**HAMDEN HIGH SCHOOL 2018 IMPROVEMENTS TO THE POOL  
2040 DIXWELL AVENUE  
HAMDEN, CT 06514**

S/P+A PROJECT NO. 18.048

**REBID NO. 2**

**DATE: February 11, 2019**

Drawing Title:  
**Lower Level Plan (Pool) - Electrical**  
Date:  
JANUARY 14, 2019  
Scale:  
1/8" = 1'-0"  
Drawn By:  
SEC  
Project Number:  
18-048  
Drawing Number:  
**E3**

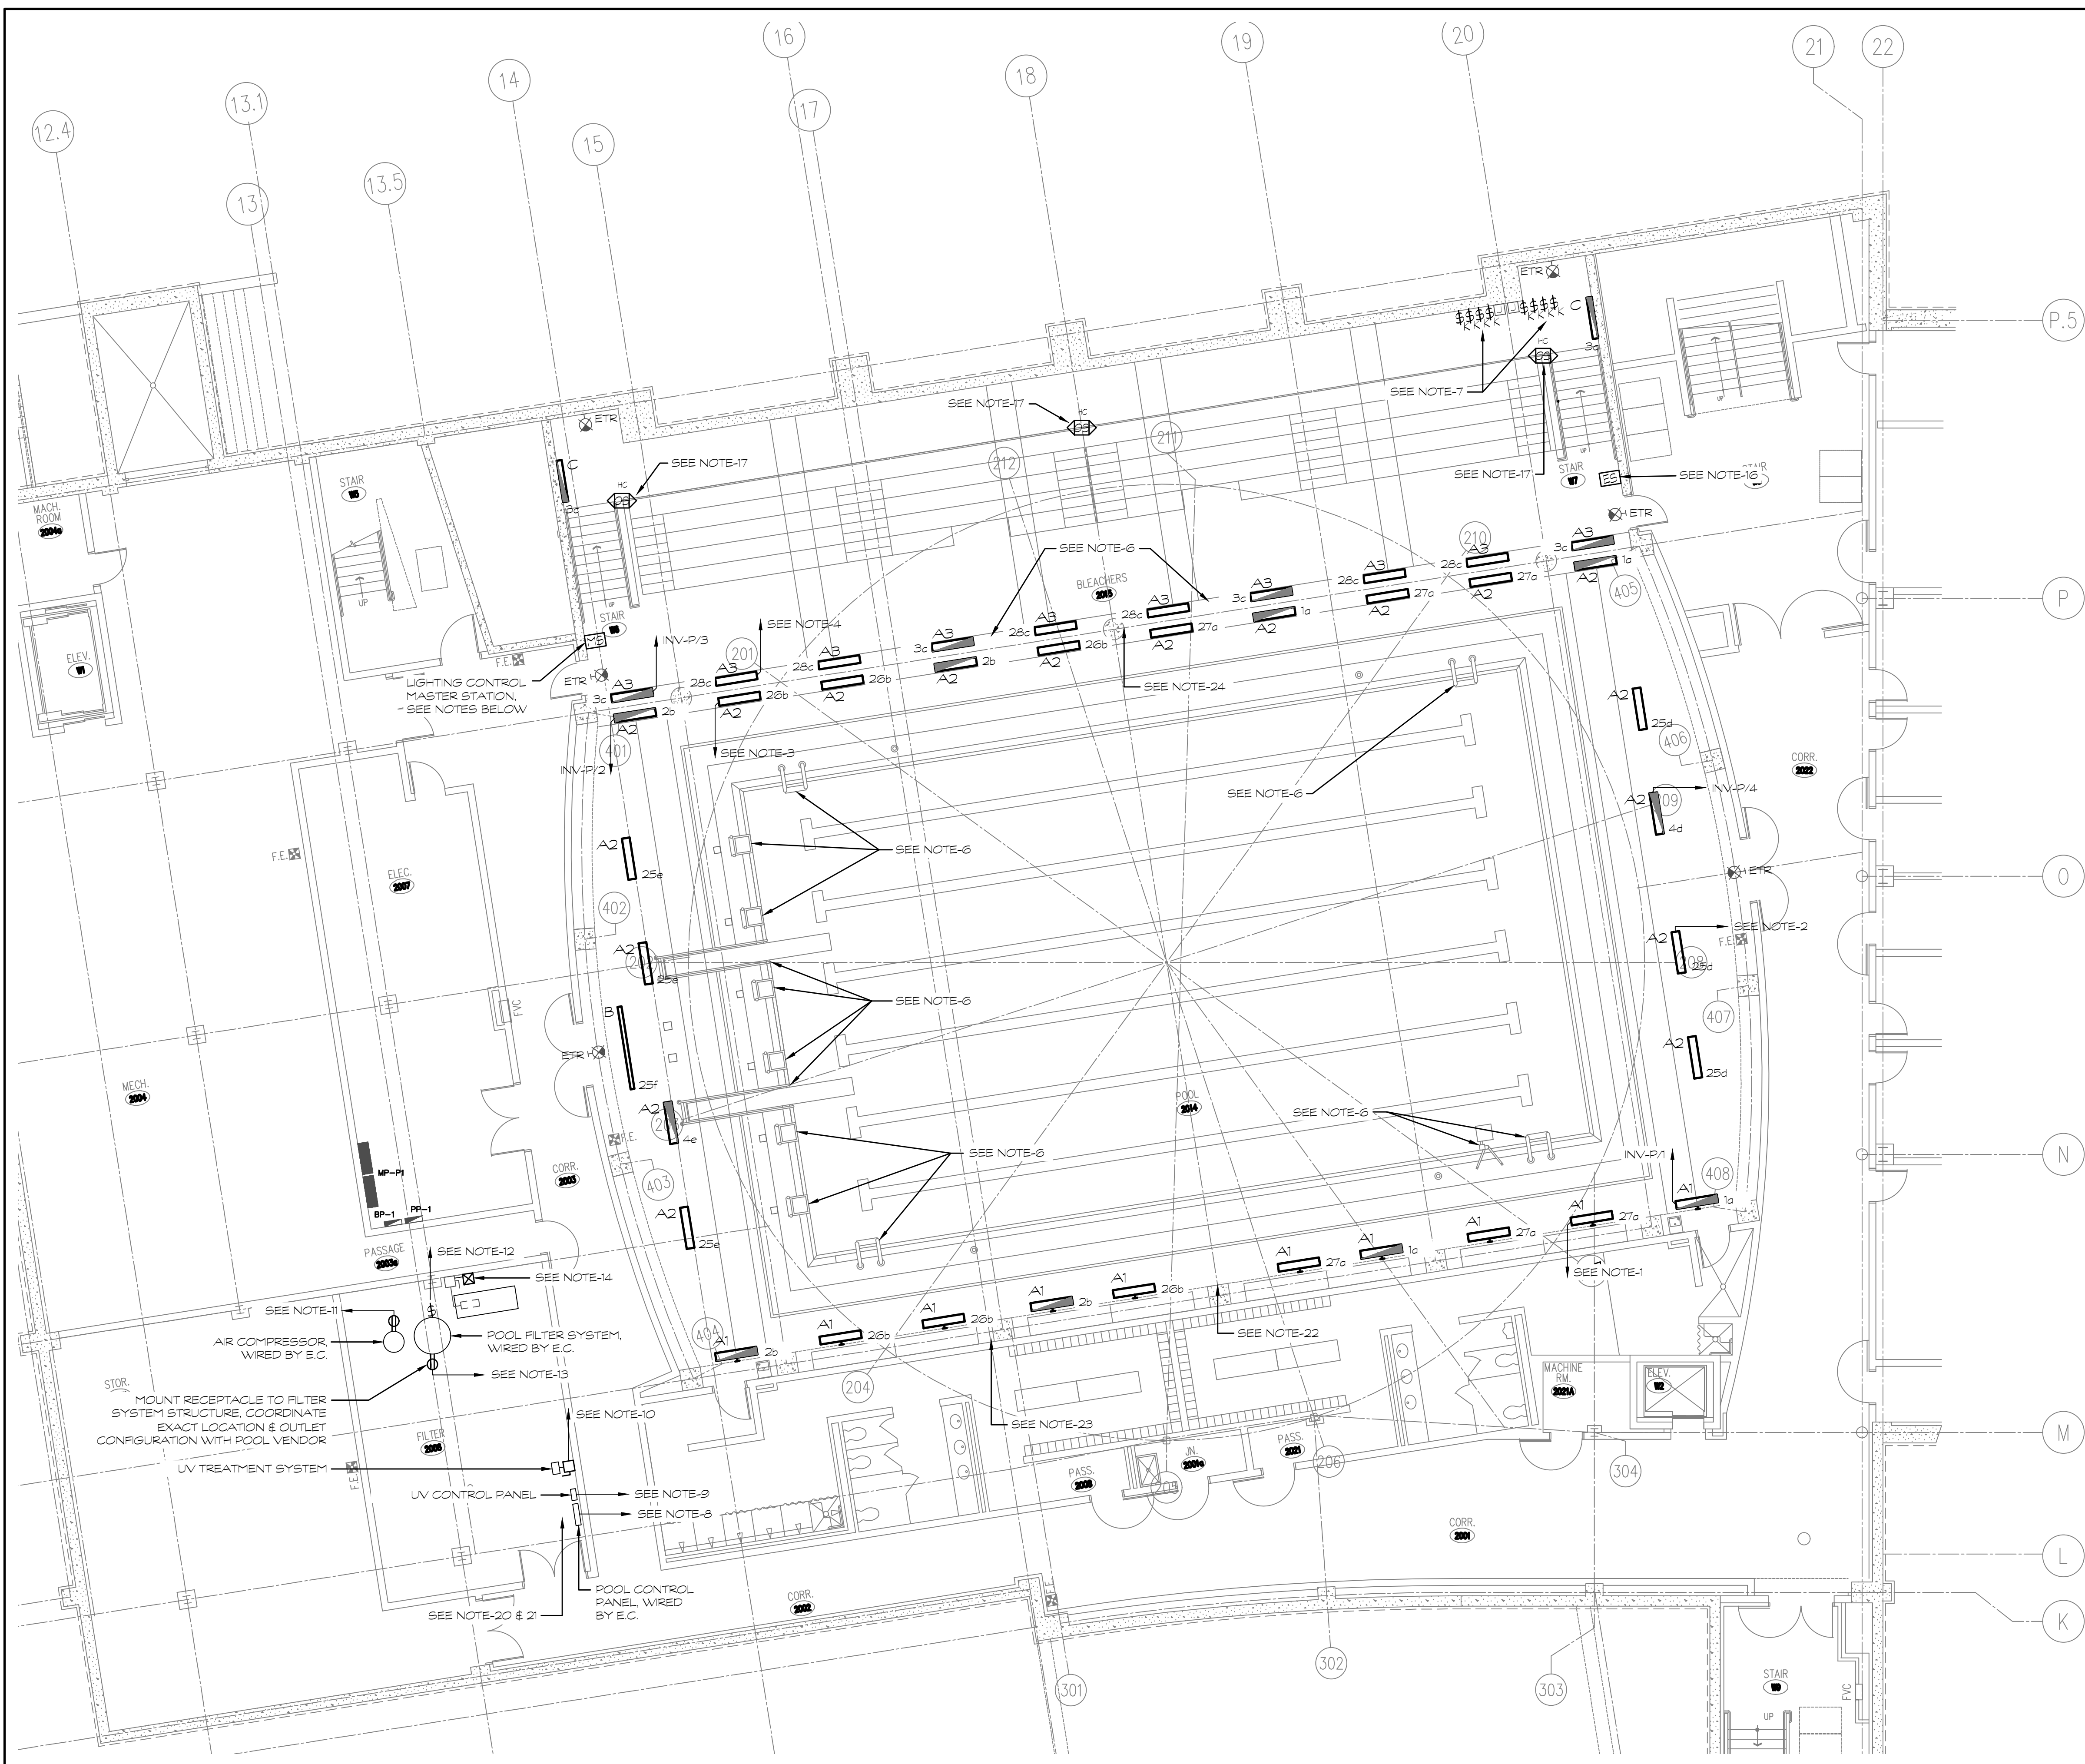
- Delete in its entirety: Drawing E-3.

Add: Revised Drawing E-3, dated February 11, 2019, attached as part of this Addendum. (1 page)
